Hunter F.G.A. Mk. 9 Aircraft - Emergency Oxygen Control Revised

A.P.4347J, Vol.2  
Leaflet No. 0.3

Hunter F.G.A. Mk.9 Aircraft - Emergency Oxygen Control revised to cater for Martin Baker Mod. No. ES.1150.

Hunter FGA Mk 9 Aircraft - To make provision for and introduce Type One Charging Valve (Ref No 6D/2244774) in place of Mk 10A Charging Valve (Ref No 6D/2313).

DRG. NO. AP4347J/02/62

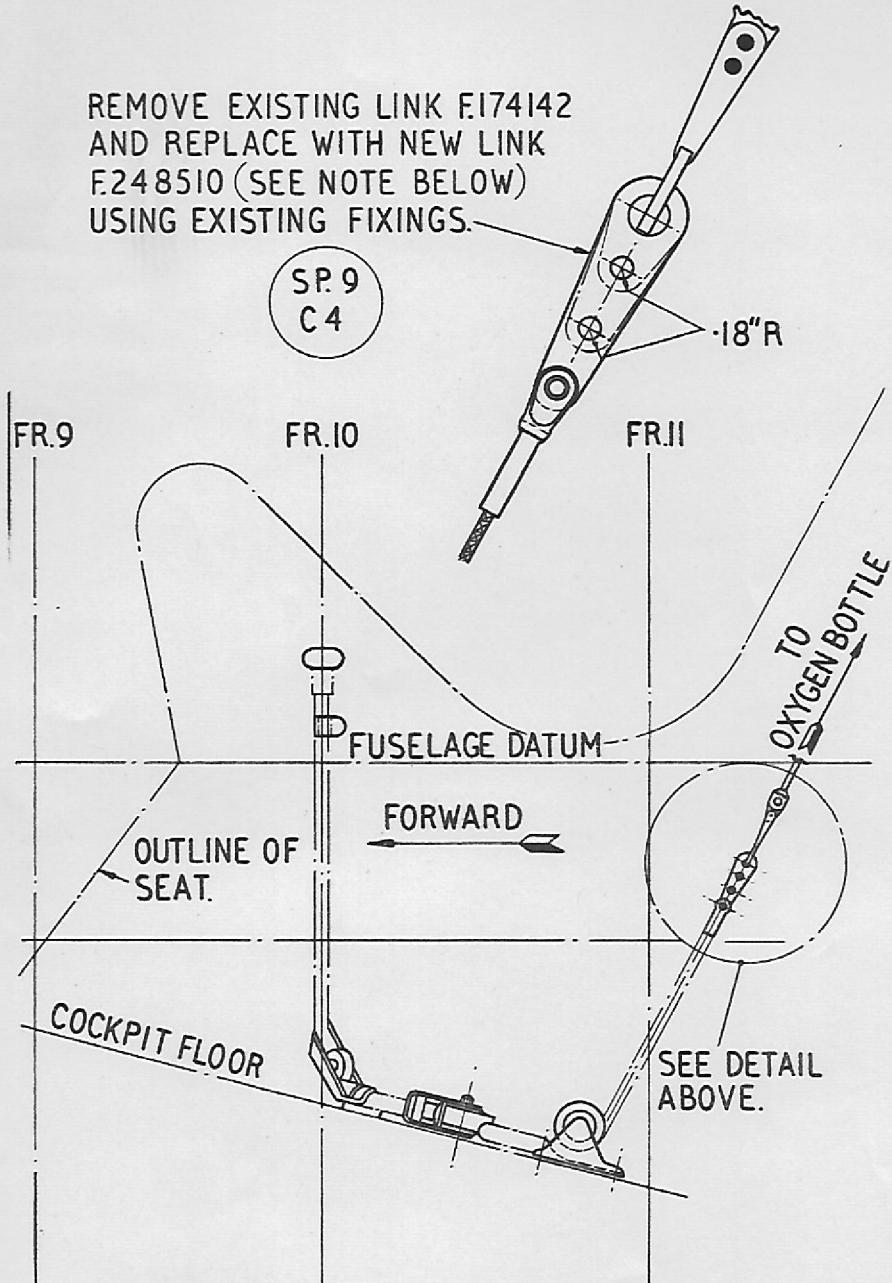
REMOVE EXISTING LINK E174142  
AND REPLACE WITH NEW LINK  
F248510 (SEE NOTE BELOW)  
USING EXISTING FIXINGS.

TO TAKE UP SLACK IN WIRE, ADJUST LENGTH BY  
PICKING UP APPROPRIATE HOLE IN LINK, AND IF  
NECESSARY CUT OFF REDUNDANT LENGTH OF LINK.

(1) Remove the existing link, Part No. F.174142, between the emergency control assembly and the emergency oxygen bottle assembly, offer up control cable to link leaving just enough slack to allow removal of link from hook and mark off fixing position on link.

(2) Fit new link Part No. F.248510 to hook on oxygen bottle assembly, offer up control cable to link leaving just enough slack to allow removal of link from hook and mark off fixing position on link.

Position, as shown on the drawing.

(4) Fit link to end of control cable, using existing pin with new split pin, Part No. Sp.9.C.4, as shown on the drawing.

(5) Re-connect the link to hook on oxygen bottle assembly, as shown on the drawing.
